## Access Compliance Report Public Rights-of-Way (Curb Ramps)

Intersection ID: 9630 Main Street: N\_SMALLWOOD\_PL Cross Street: W\_TRADE\_ST Location: N

ADA ID: 0E989E5C0AE0 Ramp Type: PerpDiag Initial Pass/Fail: Fail Overall Compliance: No Severity Score: 21.25

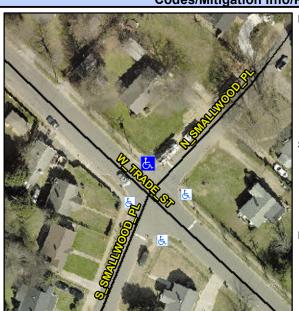
Remove & Replace Curb Ramp With
Two New Directional Ramps or
Equivalent.

PROW/ADA:
Not Found, R304.5.1, R304.2.2

Compliance Description Data Compliance Description Data No N/A Ramp Length (in) 48.5 Ramp Slope (%) 8.6 Yes No Ramp Width (in) 47.0 Ramp XSlope (%) 1.3 N/A N/A Flare Type LT N/A Flare Type RT N/A N/A N/A N/A Flare Slope RT (%) N/A Flare Slope LT (%) N/A Flare Traversable LT? N/A N/A Flare Traversable RT? N/A N/A N/A N/A DWS Provided? N/A Landing Length (in) N/A Landing Width (in) N/A N/A **DWS Contrast?** N/A N/A N/A N/A Landing Slope (%) DWS Length (in) N/A N/A Landing X Slope (%) N/A N/A DWS Full Width? N/A N/A Landing Curb? (Y/N) N/A N/A DWS Offset (in) N/A N/A N/A Shared Landing? N/A **Gutter Ponding?** N/A N/A Gutter Slope (%) N/A N/A Gutter Lip Ht (in) N/A N/A Gutter X Slope (%) N/A N/A Painted X Walk1? No N/A Painted X Walk2? No X Walk 1 Direction To SW X Walk 2 Direction To SE N/A N/A X Walk 1 Width (in) X Walk 2 Width (in) N/A X Walk 1 Slope (%) 3.2 X Walk 2 Slope (%) 4.5 X Walk 1 X Slope (%) 3.0 X Walk 2 X Slope (%) 3.7 N/A N/A N/A Ramp inside XWalk2? N/A Ramp inside XWalk1? Road Slope (%) 2.4 N/A Clear Space? N/A N/A Road X Slope (%) 5.8 Clear Space to XWalk (in) N/A N/A N/A N/A Any Obstructions? Storm Grate/Utility Hazard? N/A **Obstruction Type** Storm Grate/Utility Type N/A N/A Yes Surface Condition? (G/P) Good
